A High Level Mining Review of the Bowdens Lead, Zinc, Silver Project

Report prepared for the Lue Action Group, July 2020.

Michael White

Part of Waste Rock Emplacement Design Elements Figure A5.4⁷

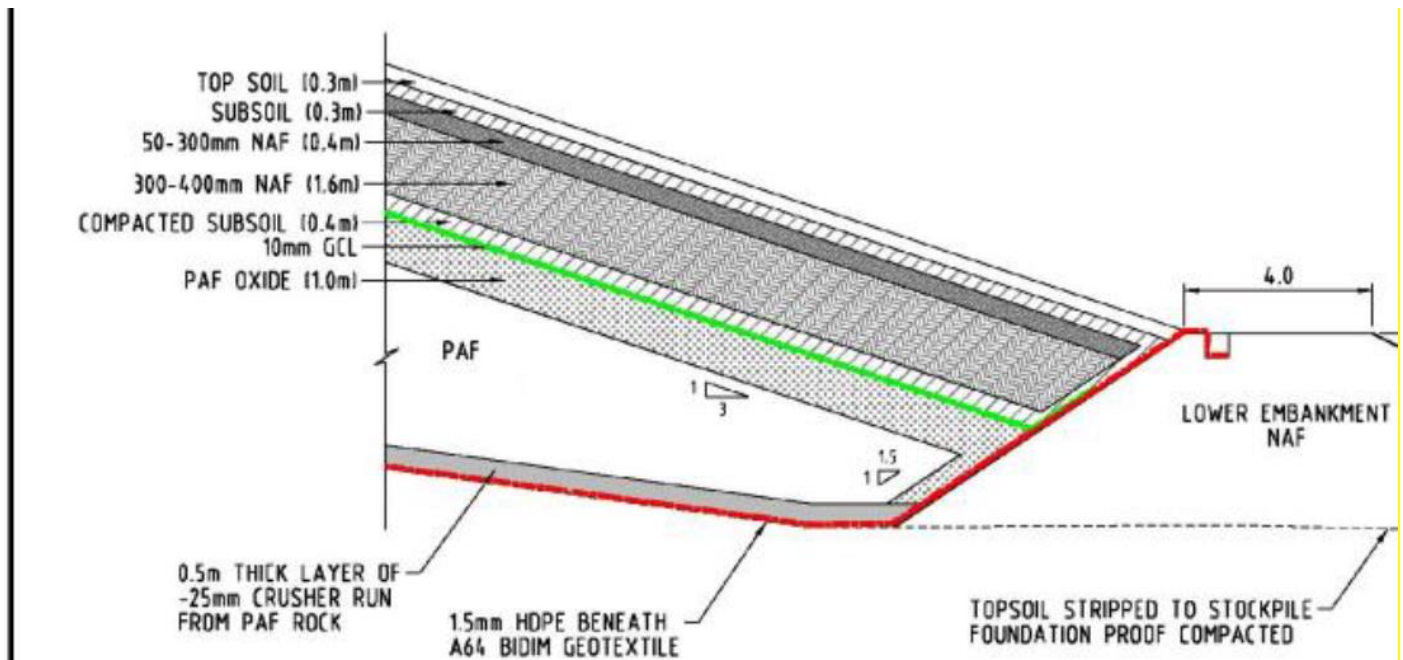
The success of this design depends on the integrity of the 1.5mm HDPE liner. This liner is proposed to be placed on a geotextile mat, double welded at joins and then covered another geotextile mat and then covered by 0.5 metres of minus 25mm crushed rock. Run of mine PAF waste rock is then dumped on this crushed rock.

At the base of the WEA a consistent coverage of crushed PAF rock at 0.5m will be difficult to achieve due to the irregular underlying natural surface. It is proposed to place the liner on a geotextile fabric directly onto the natural surface.

Damage to the liner could occur from sharp material above or below the liner. A sharp rock or remaining tree root below the liner could result in a perforation as weight is applied by loading from above as the waste rock is deposited.

If a large angular piece of run of mine PAF waste rock falls or rolls from height onto the 0.5m crushed rock layer above the liner this could perforate the liner and this would not be necessarily detected during operations.

Damage to the liner will not be detectable as the waste rock is dumped into a cell and if leakage is subsequently detected through water monitoring below the WEA then finding the location and fixing the leak may not be possible.

Once a cell is filled it is proposed to seal the cell by covering it with a multi-layered “store and release” cover as shown above in part figure A5.4.

The cover will need to be constructed on a 1 in 3 slope and consists of seven distinct layers which includes a Geosynthetic Clay Liner (GCL)

EIS Tailings Storage Facility Layout¹³

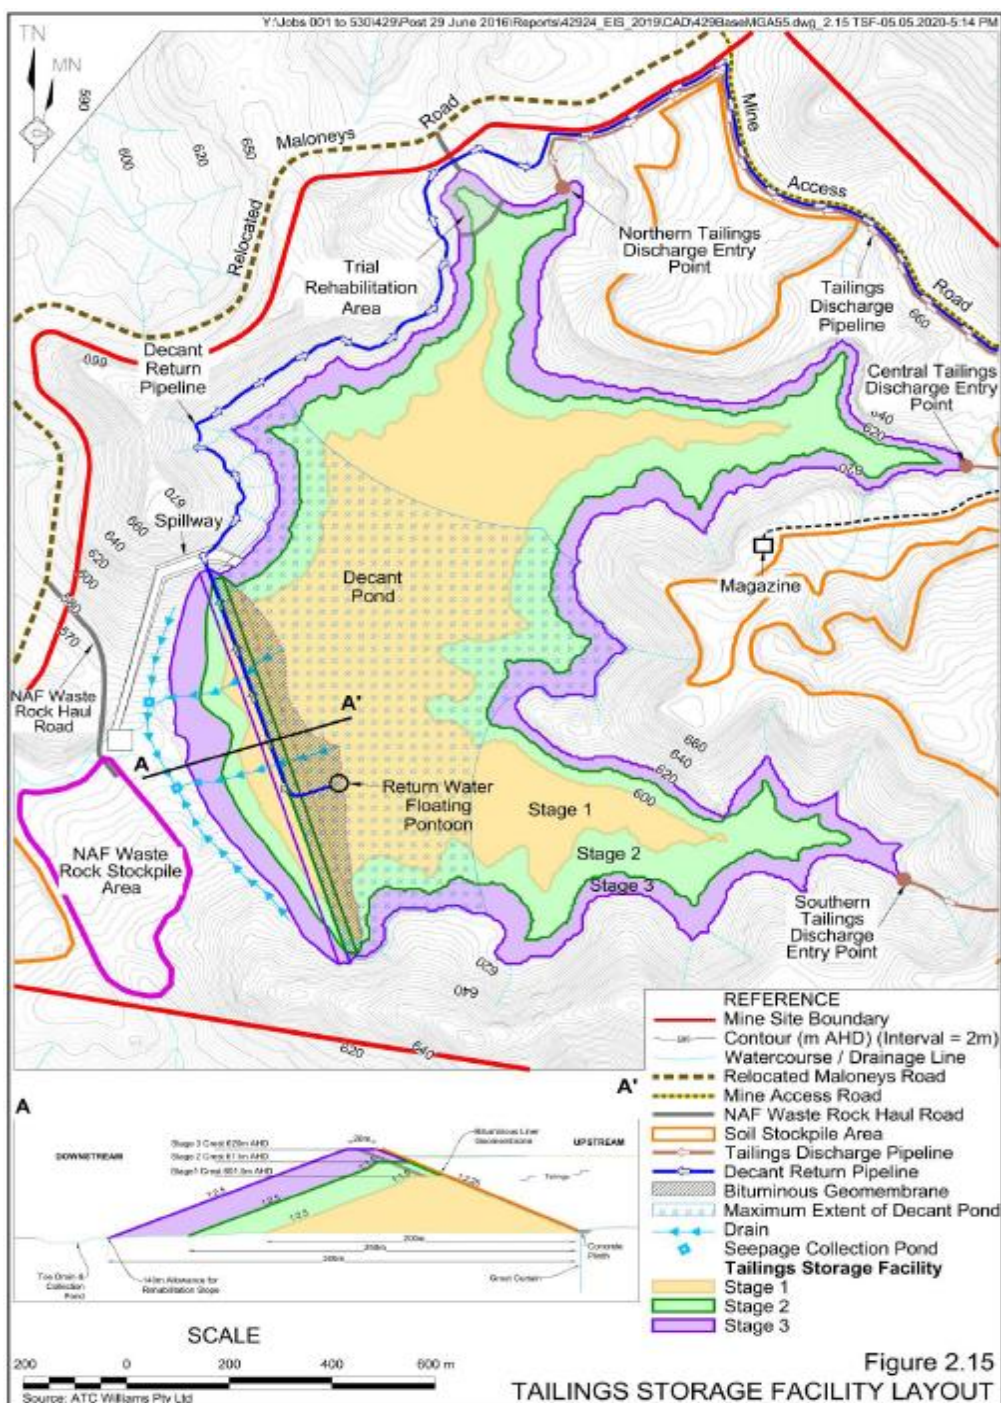
There is no detail provided as to how this reduced permeability target is achieved in the impoundment area remote from the decant pond.

There is no information provided as to how long this will prevent acid water containing heavy metals from seeping into the surrounding environment. There is no information provided as to where this design has been successfully used for an AMD tailings dam in the short term and long term.
